Product: *Integrated Amplifier*

Hardware Technical Bulletin: *C372-H2005-01*

Subject: Power supply capacitors

Figure 1 (Original layout, showing cracked solder on jumper wire)

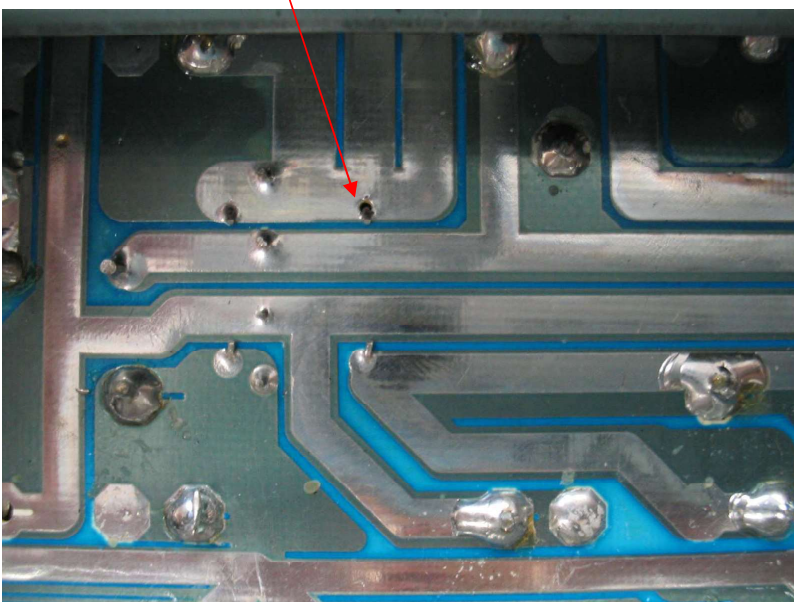
REASON:Solder pads around jumper wires have higher than normal resistance causing power supply ripple to increase across filter capacitors. See figure 1.

Figure 2

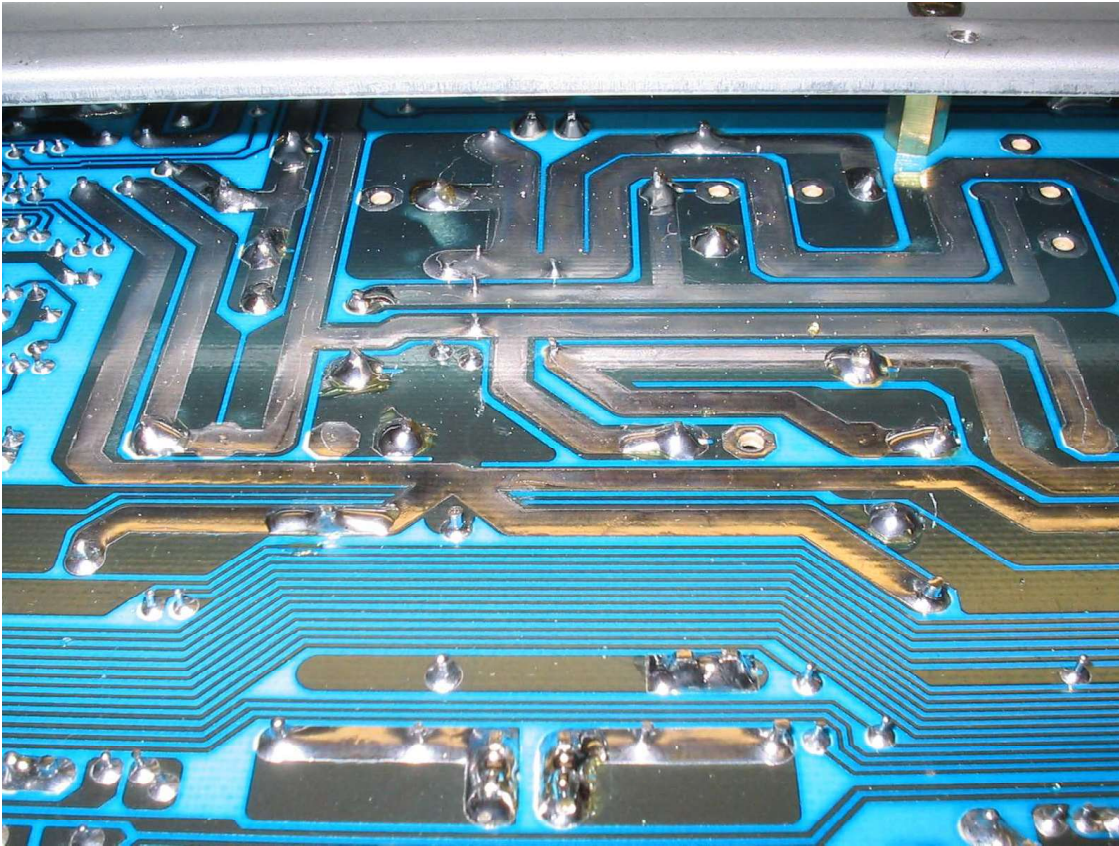
SOLUTION:Add 18 gauge wires to thePCB to lower the circuit resistance.To install this modification, first remove the bottom service plate. Look for the PCB area shown in figure 2. In figure 3, the addition of black jumper wires to lower the resistance of these pc board traces is shown. Capacitors showing any signs of stress or damage should also be replaced at the same time.

Figure 3

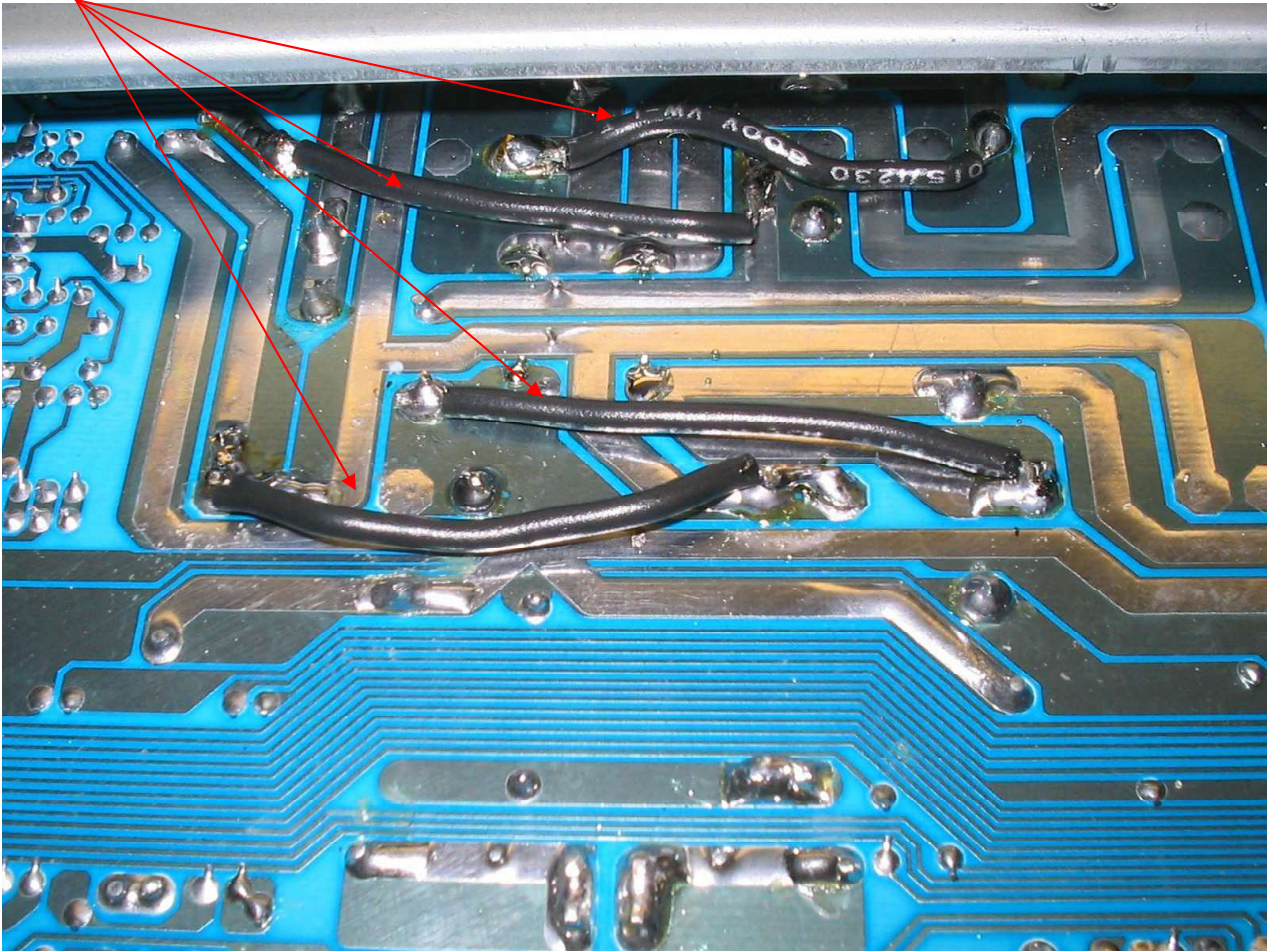
Four wires shown below

Positive supply , add this wire between these two pads

Common/ground supply, add these two wires as shown between these pads

Figure 4

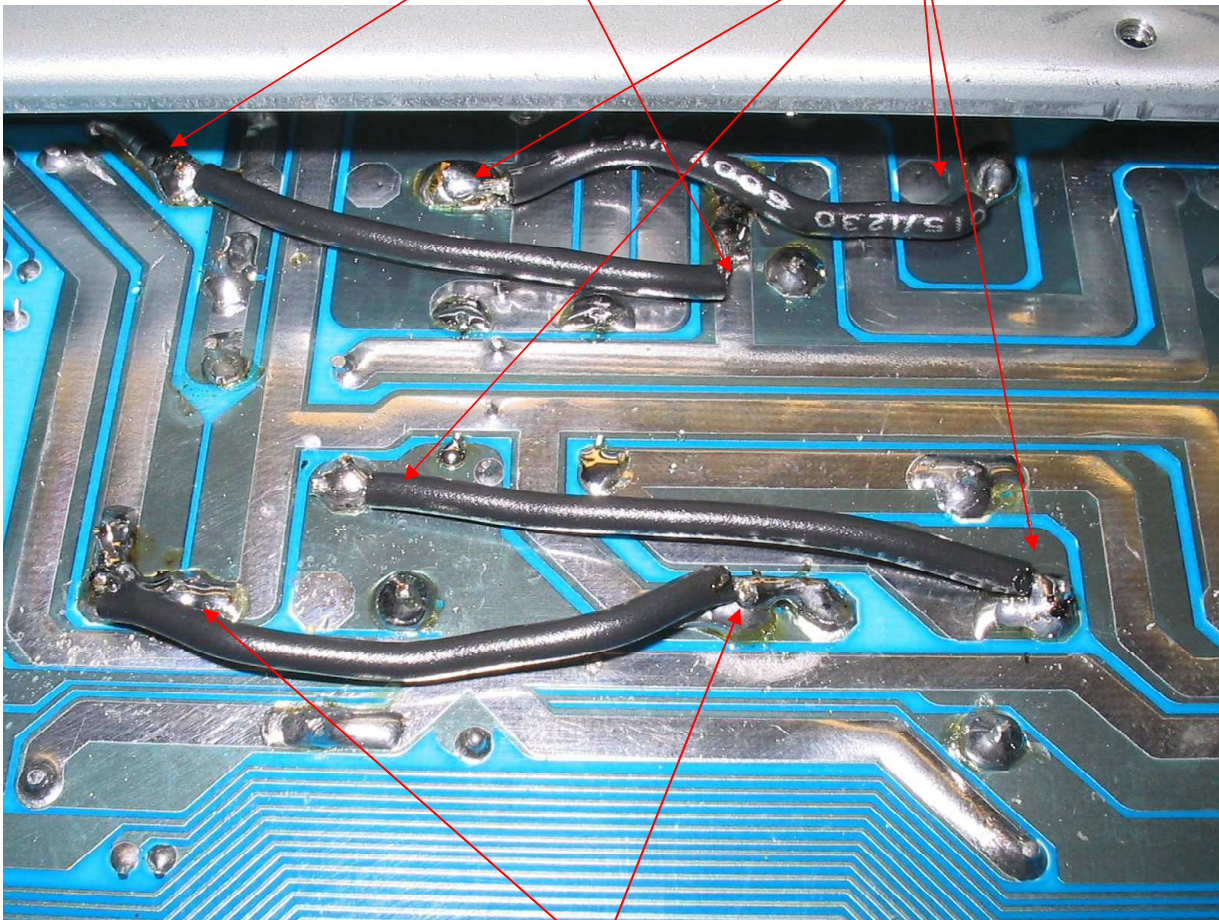
Alternative view showing four wires

Negative supply , add this wire between these two pads
